Project Number: P2120

**Subject: City of Ottawa and South Nation Conservation review of OPA
and ZBA application submissions for 6150 Thunder Road
D01-01-20-0025/D02-02-20-0310**

Figure 1: 100-year floodplain extent

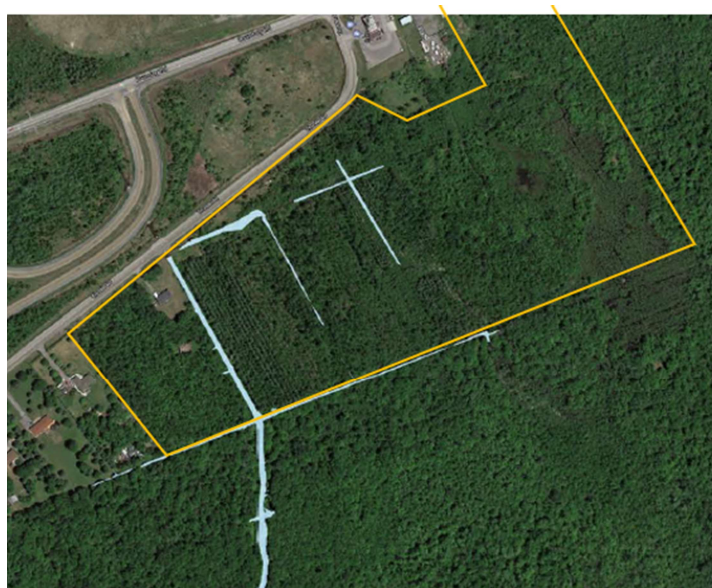
Subsequently, the JFSA report, entitled '6150 Thunder Road: Floodplain Mapping' dated July 2021, undertook a detailed hydrologic and hydraulic analysis which demonstrated that the 100-year floodplain in the adjacent tributary to Bear Brook allows for a significant area of developable land above the flood elevation. The 100-year floodplain is contained in the banks of the Bear Brook tributary and minor channels as shown in Figure 1.

Further to above, the report demonstrates that the floodplain does not exceed the banks of the channels, therefore the placement of fill on this site for the purpose of development grading, shall not interfere and will have zero impact on the extent of flooding upstream or downstream from the property.
